**AGENDA**  
**BEDFORD COUNTY PLANNING COMMISSION**

**REZONING APPLICATION**  
**RZ21-0003**  
**TPB Enterprises**

SUBJECT: ***Rezoning Application #RZ21-0003: C-1 and C-2 to R-4, TPB Enterprises (Rustic Village Apartments)***

RE: RUSTIC VILLAGE – RESPONSE TO TIA REVIEW  
COMMENTS

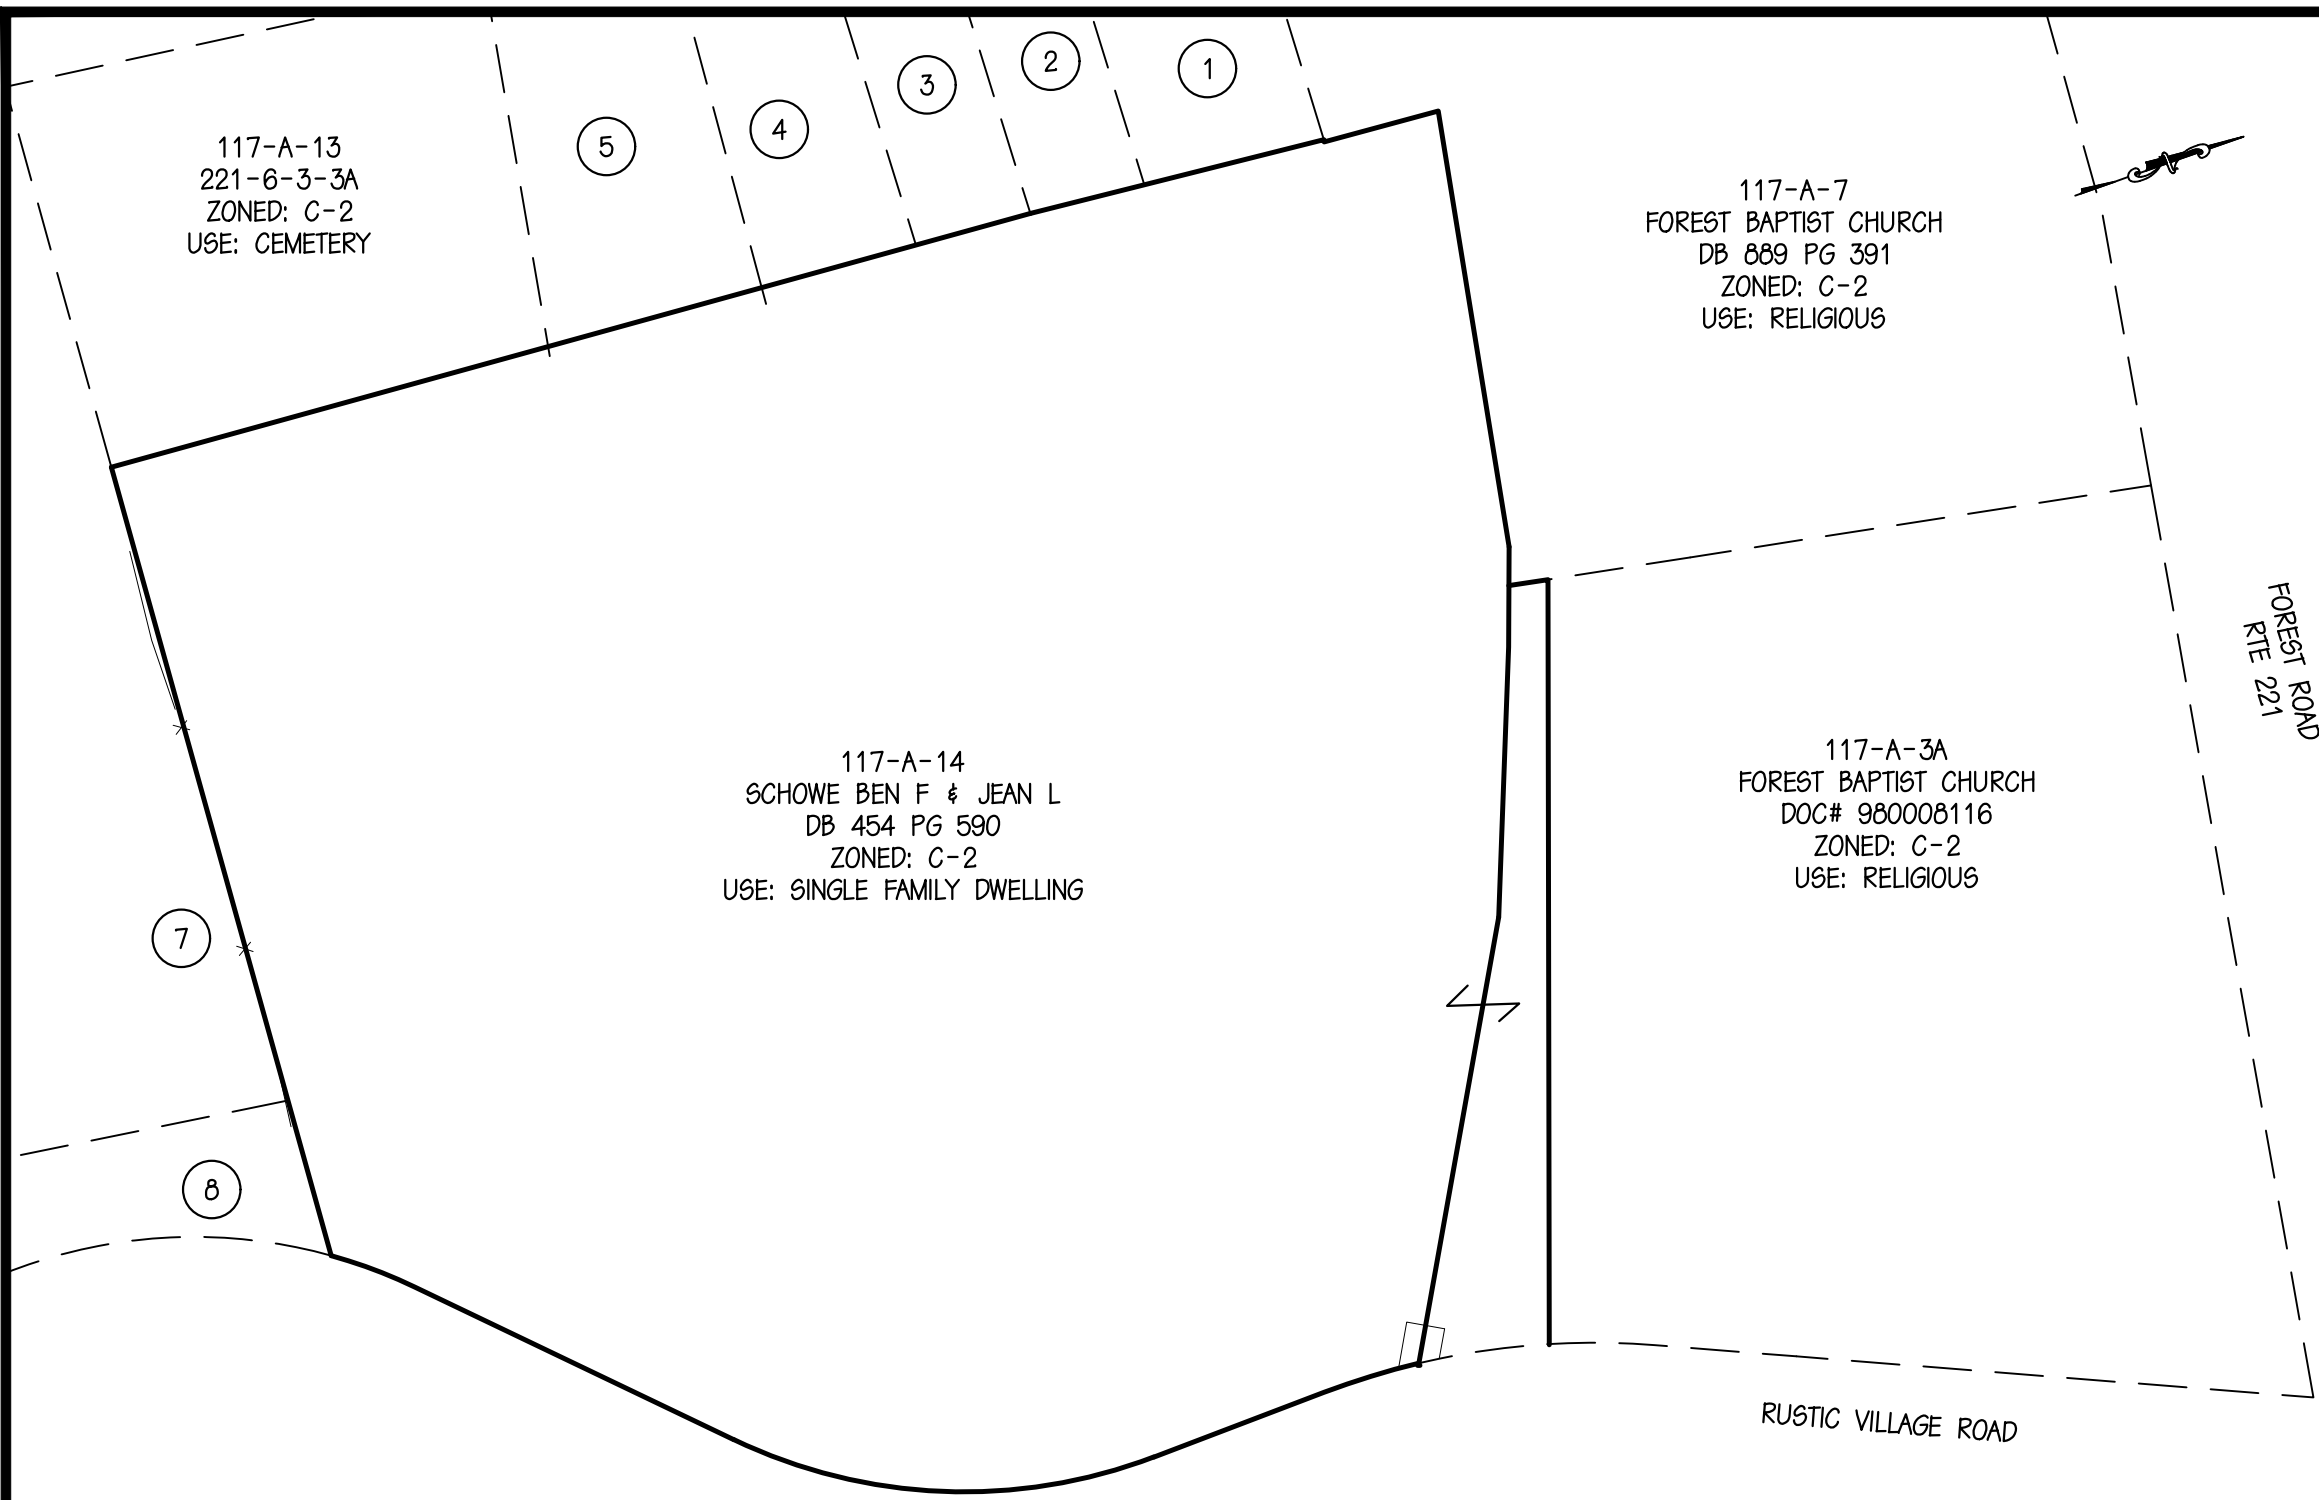
The Bedford Residency has completed a review of the submitted untitled Plan Sheet as received by email on May 19, 2021, for the above referenced project and has the following comments:

1. VDOT is in receipt of a TIA to support the proposed layout and any impacts to VDOT facilities, as received on May20, 2021. This is currently in review by VDOT Traffic.
2. Rustic Village Road, Route 609, is classified as a local road. Access management is not a review requirement. VDOT does not object to the use of two entrances in this situation.
3. As proposed the site will require two commercial entrances for access to the internal private roadways.
4. Sanitary sewer proposed in the existing prescriptive easement for Rte. 609 will require a permanent BRWA easement from the underlying property owner. Issuance of a Land Use Permit at this location is constrained to allowing traffic control within the easement. VDOT will coordinate with BRWA relative to location and width of the easement.

5. When submitted the site plan must demonstrate:
  - a. The proposed entrances comply with the design requirements in Appendix F.
  - b. Grading and drainage do not increase discharge to the right-of-way at any point along the frontage. Existing site runoff enters the right-of-way at two locations, the use of one storm water management facility may require extensive engineering.
